RE: 2019/5709/P

I write to object to the plans to convert the 12 garages behind 521 Finchley Road into 2 houses. While I support the use of brownfield sites for extra housing in Camden, I believe that the planned work will make the area unsafe for pedestrians and bikes.

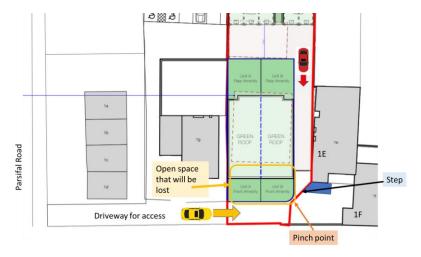
I have included a diagram below to illustrate the issue. At present, the only access to 1E and 1F is a driveway running down from Parsifal Road past the garage area which will be redeveloped in this application. The space in front of the existing garages (yellow rectangle below) is a wide open area which is used as a walkway by pedestrians accessing 1E and 1F as well as those going to the back doors of 521 Finchley Road. The area is also used by children playing on bikes, and the wide space here makes this a safe activity. If any cars do approach, there is plenty of room to share the road with bikes and pedestrians.

There are two problems with how driveway will change in the proposed plans. First, in the proposal, the front garden of Unit B extends within 1m of the boundary of the property (red line). If the garden were built like this, it would not be physically possible for a car to drive from Parsifal Road to the proposed garages, because the car could not drive past the pinch point (see diagram). Note that part of the space outside 1E adjacent to the pinch point has steps and the rest is often full with parked cars.

With regard to my second point, I make the assumption that the developers might keep one corner of the front garden of Unit B as a roadway to let one car drive past the pinch point. However, this does not resolve the more important issue, which is the use of the driveway as a shared space. I believe that the narrow driveway left after the proposed building work cannot be safely shared between cars, bikes and pedestrians. In particular, the pinch-point is dangerous because when one car drives down from Parsifal Road (yellow car) and another leaves the garages (red car), they will meet at the pinch point, where the footprint of Unit B leaves no space to turn or pass. There is no line of sight for the cars to see each other because Unit B is in the way, and the yellow car will then

be forced to reverse uphill on the long narrow driveway and turn out backwards onto Parsifal Road. The driveway is a shared surface used by cars, bikes and pedestrians, including daily use by school children. It is therefore not safe for cars to reverse on this space. Allowing this seems contrary to all Camden's planning guidance to support pedestrians and bike users (some links are included below).

For this reason, I suggest that the current plans should be rejected. I would have no objection to a development with a smaller footprint which allows for cars to turn or pass each other at the pinch point and for pedestrians and bikes to have safe access to all the houses.
